**Board of
Zoning Appeals**

Agenda (AMENDED)

Board of Zoning Appeals
Thursday, April 21, 2022

**STAFF REPORT
BOARD OF ZONING APPEALS
APRIL 21, 2022**

**GARAGE
TROY & EMILY GREEN RESIDENCE**

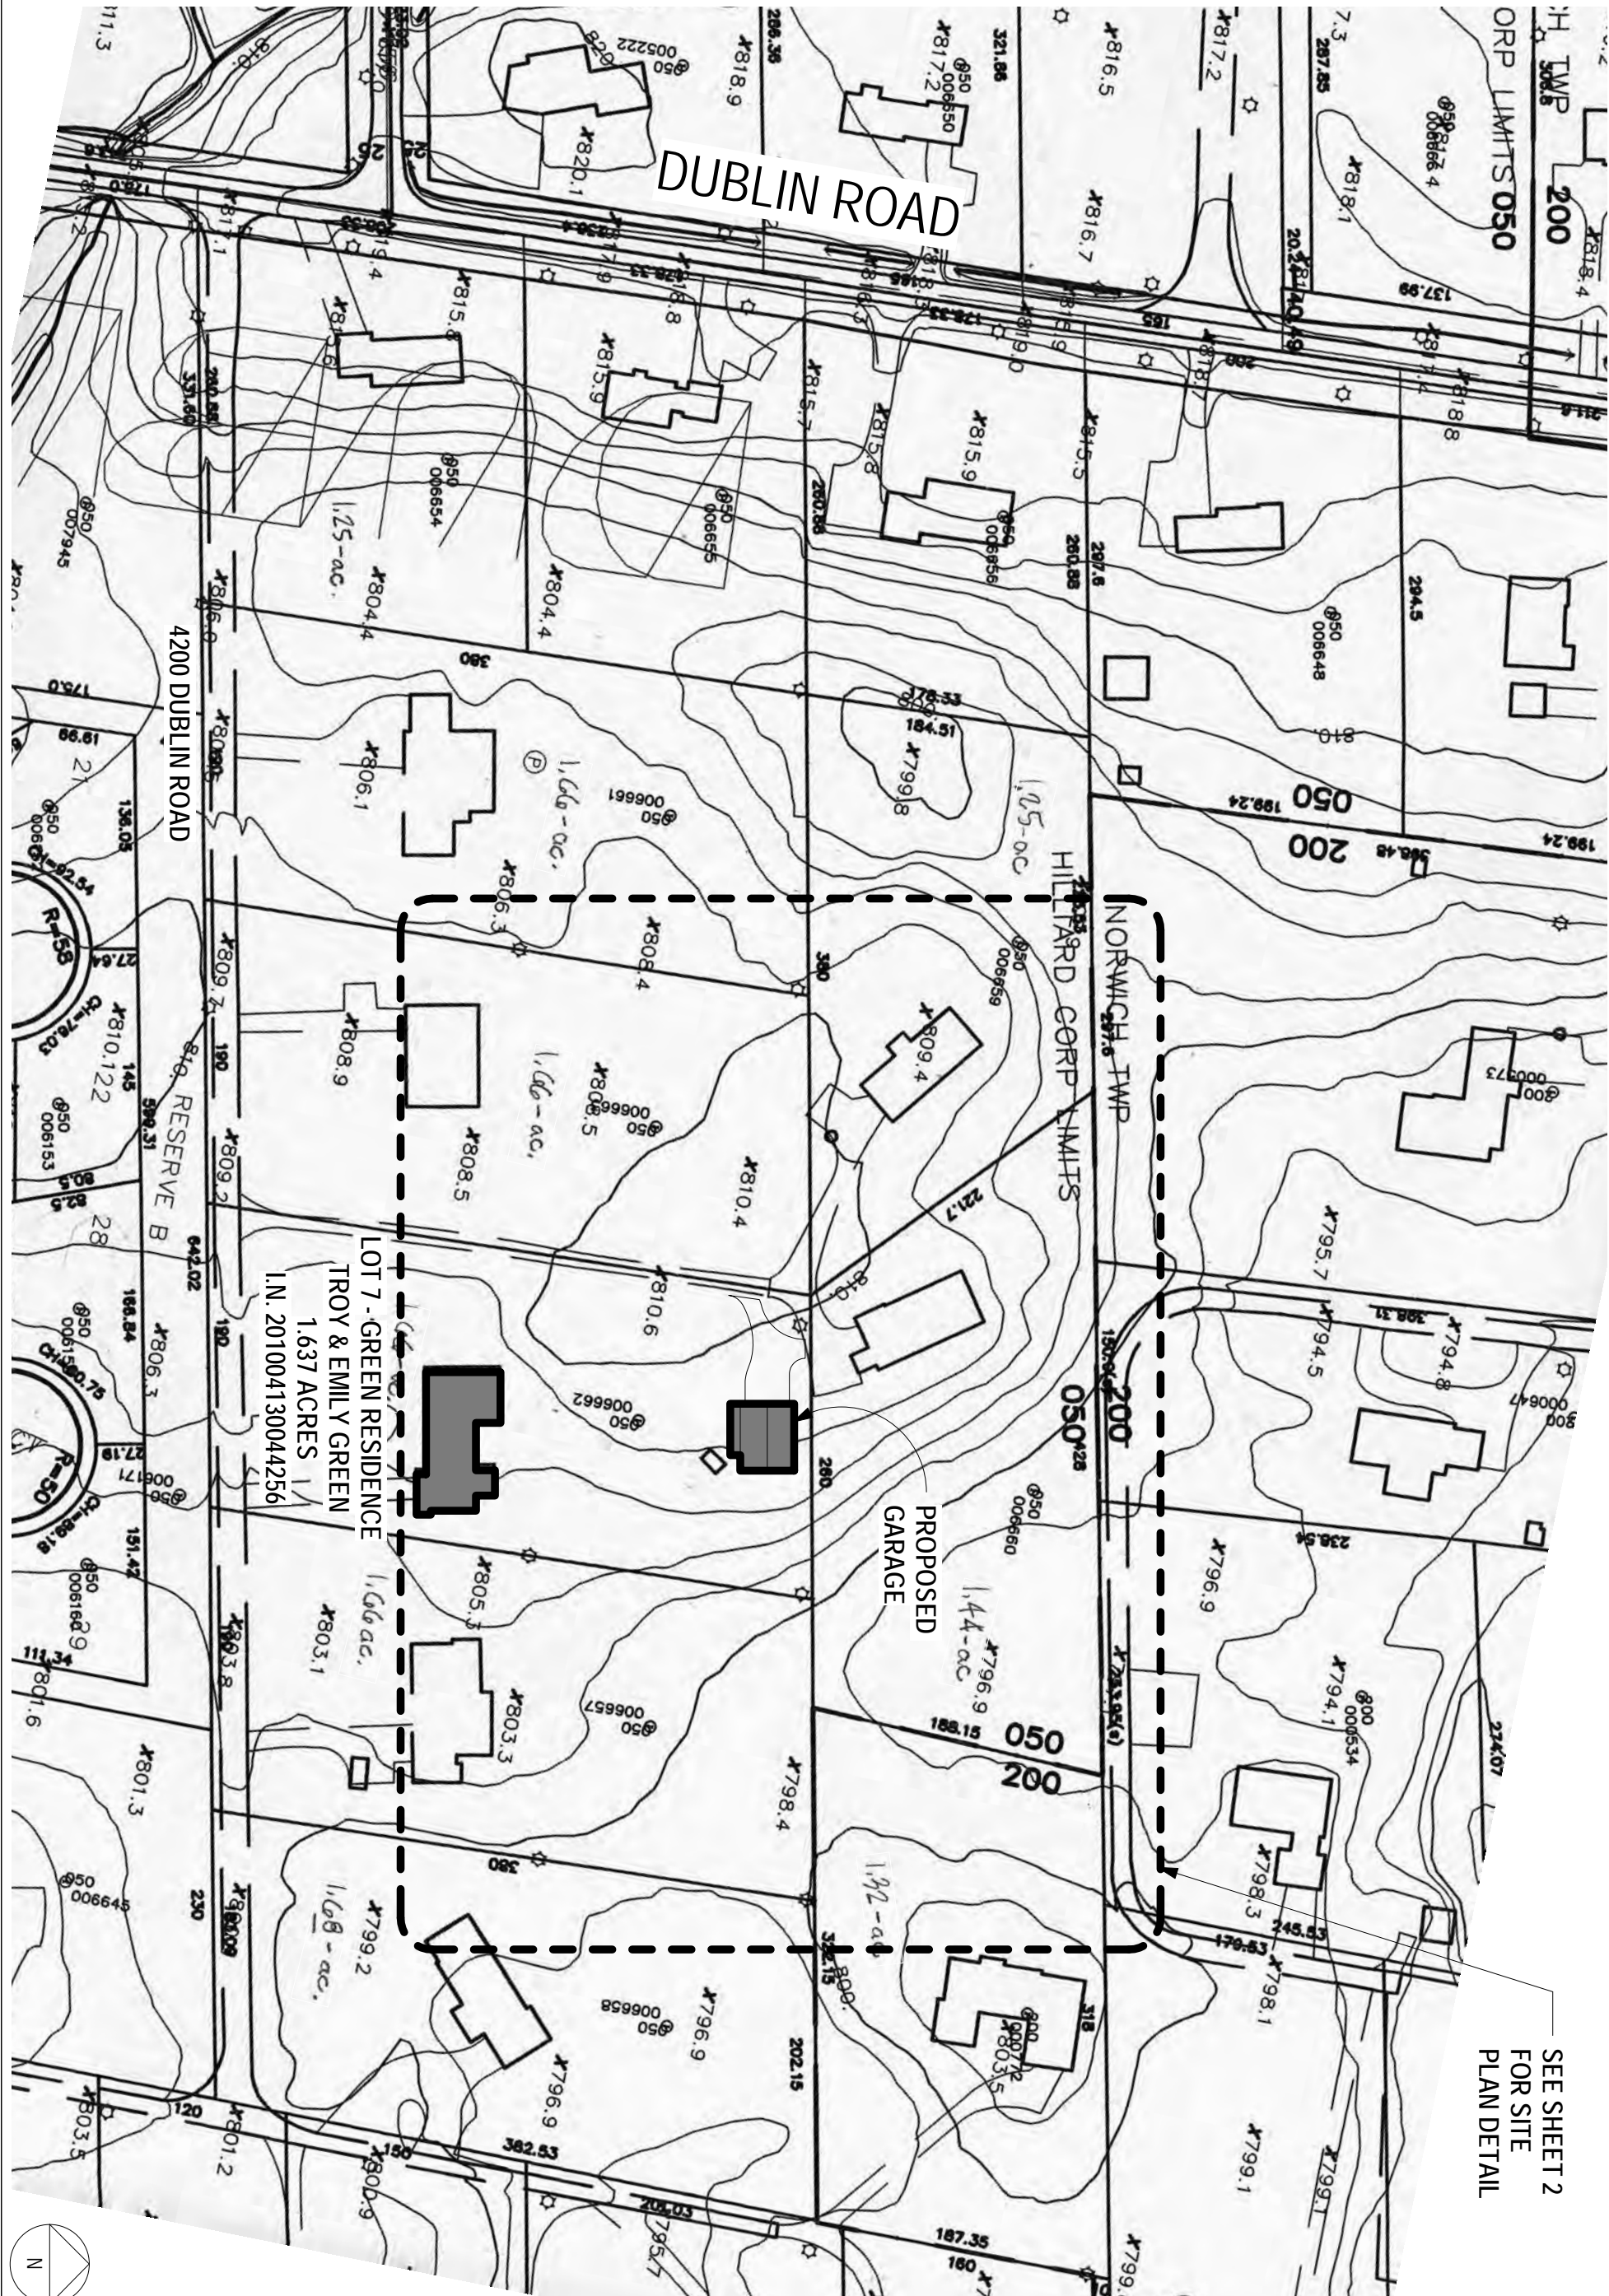
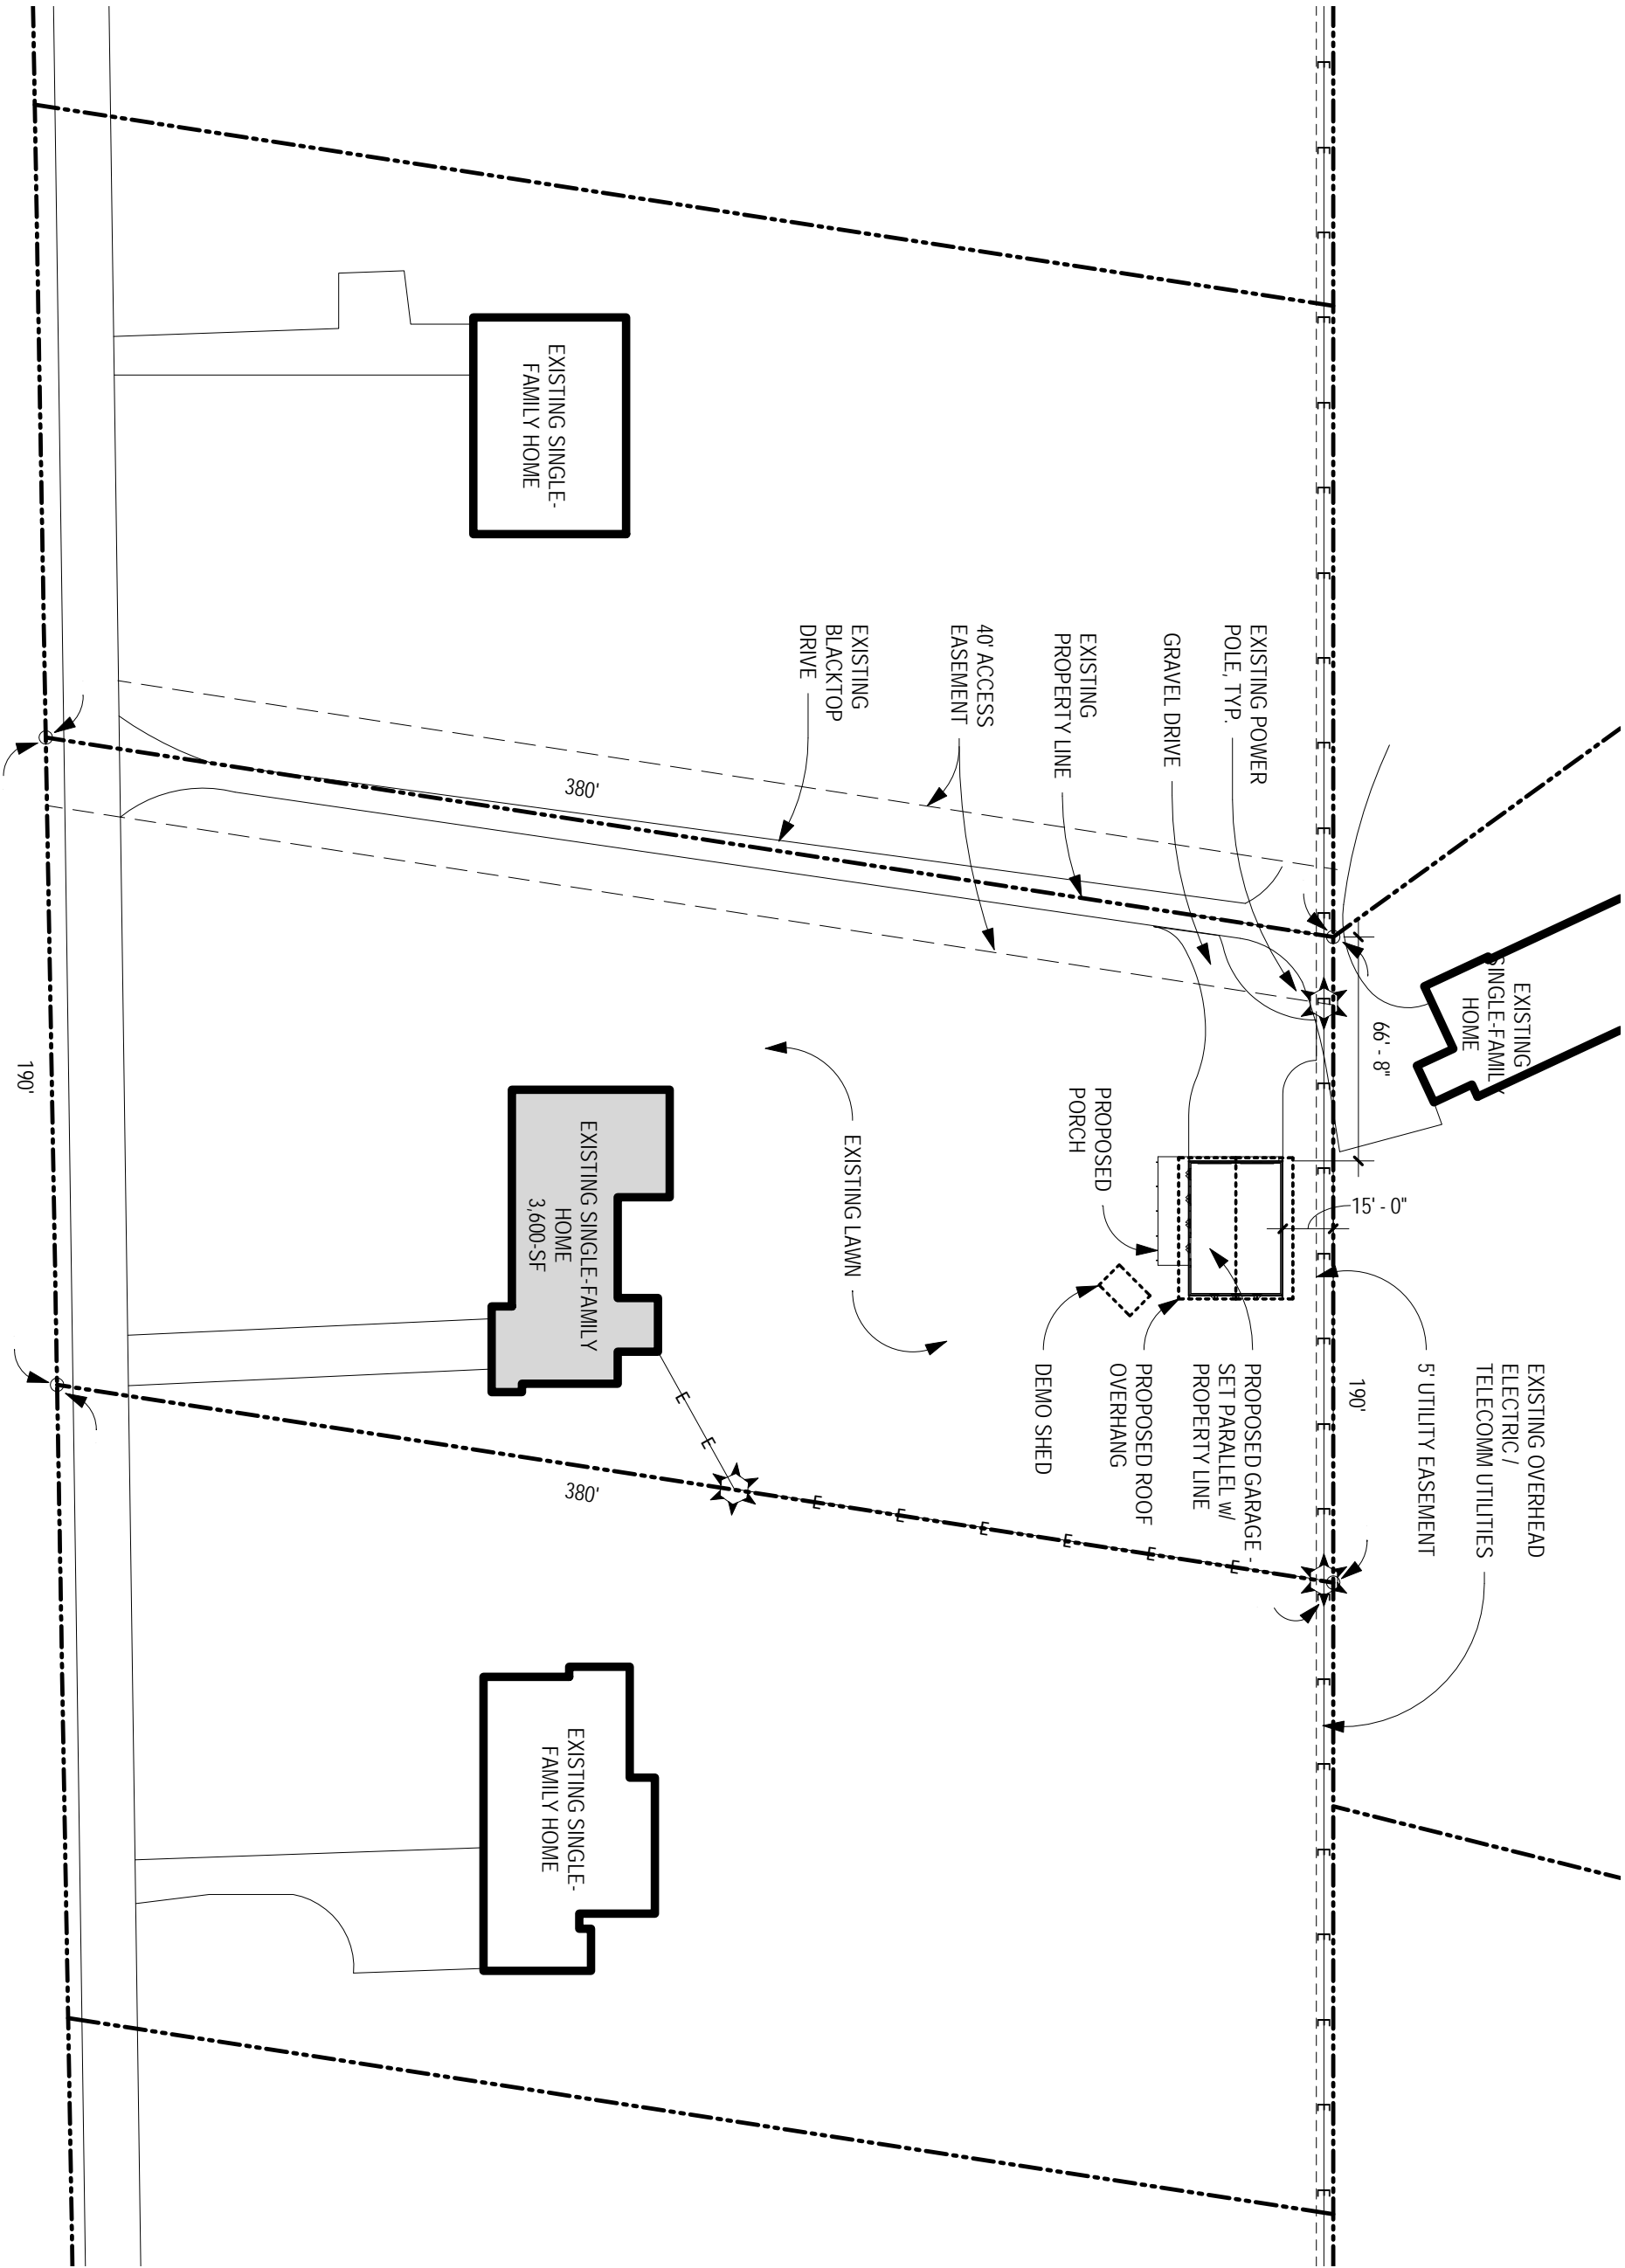
- The garage will be 18-feet in height measured per code; the first story will function as a garage and the second story shall provide storage space as previously approved. Architecture for the garage integrates with the surrounding buildings and features numerous elements to provide variation on each elevation.

- Access to the accessory building is provided via a shared drive with the two residences north of the site. Plans include a gravel connection from the garage to this shared access drive.

Staff finds that there could be a beneficial use of the property without the variance, but that the proposed variance to permit a slightly larger structure will not impact the character of the neighborhood and is not substantial given the nature of the property and the proposed location. The proposed variance will not adversely affect services, and the proposal is consistent with the general spirit and intent of the Code. Based on these findings, consistent with the provisions of Hilliard Code Section 1121.02(b)(7), staff recommends approval of the increased accessory building size with four conditions:

- 1) That the proposed garage is limited to 18 feet in height, as measured by Code;
- 2) That the gravel driveway be permitted as previously approved;
- 3) That the existing accessory structure be removed before or at the time of completion of the new accessory structure; and
- 4) That a zoning certificate and required permits be obtained prior to construction.
